# Agenda Report

July 10, 2017

**SUBJECT: PREDEVELOPMENT PLAN REVIEW OF A 258 UNIT MULTI-FAMILY RESIDENTIAL (URBAN HOUSING) COMPLEX, REMODEL OF AN EXISTING STANDALONE RESTAURANT BUILDING, AND PARTIAL EXTERIOR REMODEL OF AN EXISTING OFFICE BUILDING, LOCATED AT 3452-3488 EAST FOOTHILL BOULEVARD**

**Proposed Site Plan (Ground-Floor)**

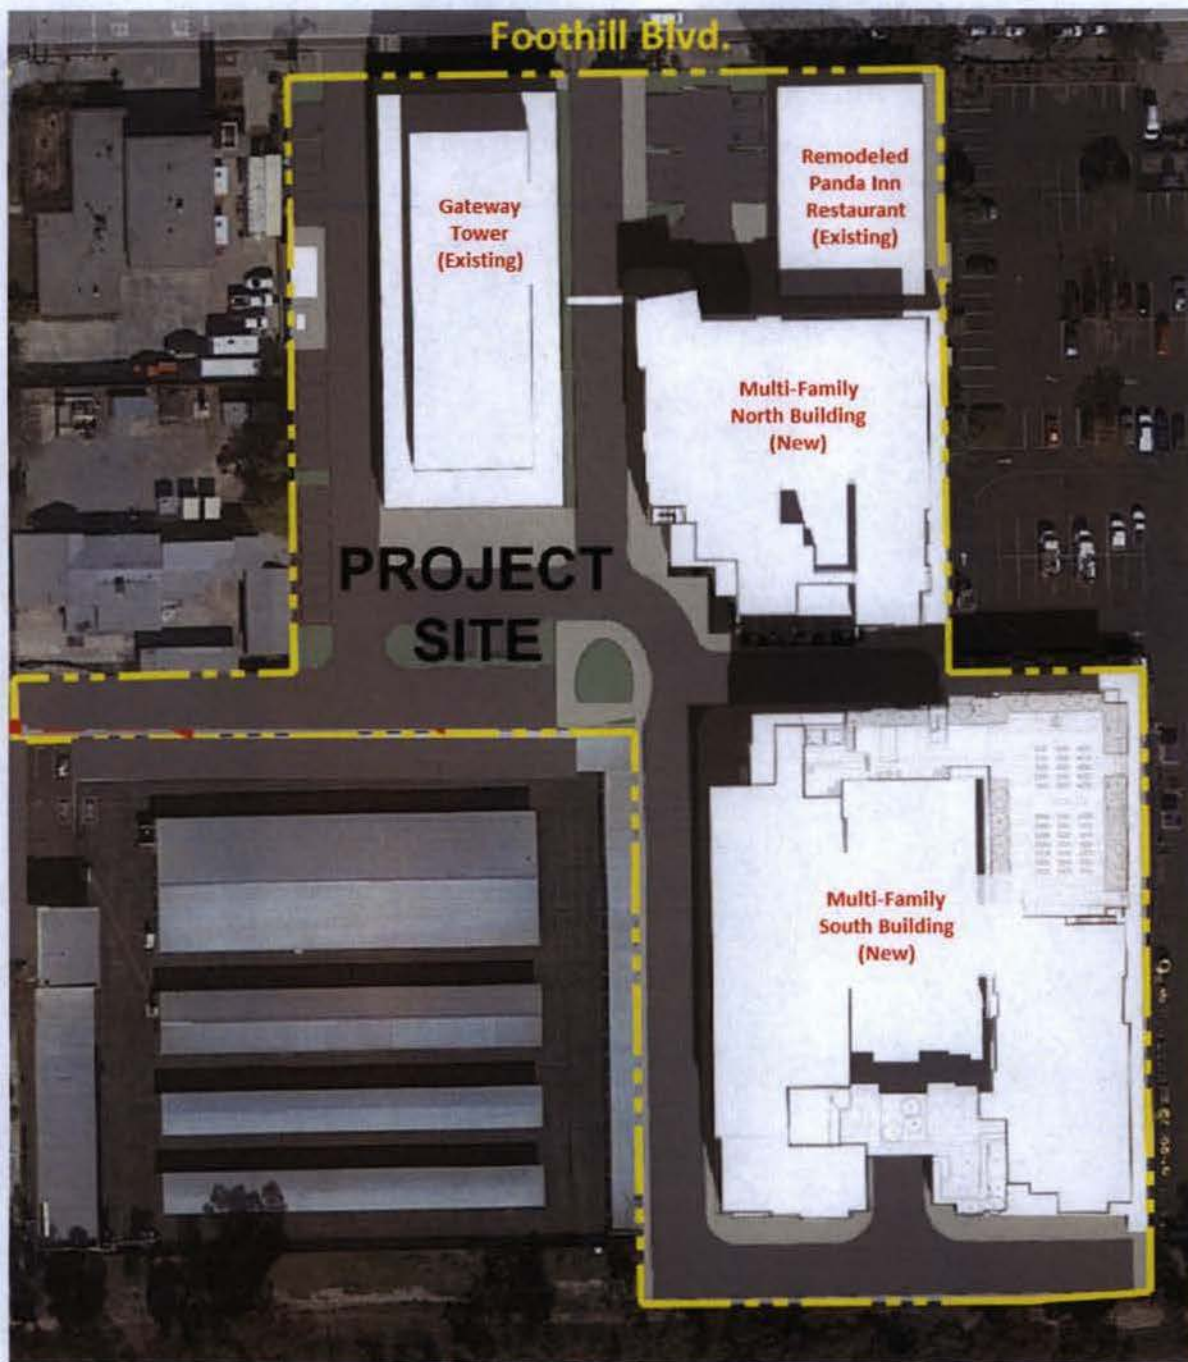
the remodel to the restaurant building. Setback requirements for Urban Housing use are established per 17.50.350.C. The required side and rear setbacks for the multi-family buildings is 10' minimum; however, through the Design Review process, the side and rear setbacks may be reduced if the reduction results in a larger courtyard. The proposed project provides a zero setback on the east property line and a rear setback greater than 30 feet. Through the Design Review process, if a reduced setback is maintained along the east elevation, the plans should reflect adequate information to show a resulting larger courtyard.

*Siting:* Siting of the restaurant at the minimum property setback with the focus on the front entry vestibule meets the objectives of subarea d2, including using an entrance as a special design element. The applicant may consider removing the at-grade parking area west of the restaurant building, or a portion thereof, to create an active pedestrian-oriented space and create a sense of place at the street edge, possibly including the required public art feature into this, a fountain, street furniture, outdoor dining or seating, and landscaping.

*Landscaping:* Landscaping will be reviewed in more detail during Final Design Review and all areas not used for building and circulation should be landscaped. There is special emphasis on landscaping in East Pasadena and a design for a low wall and landscaping to screen the at-grade parking lot west of the new restaurant should be included in the plans. Refer to the ESPS Design Guidelines Section 6.5.4, Figure 6-15, Section 6.5.8, and Figure 6-17; as well as PMC Section 17.32.080.A.
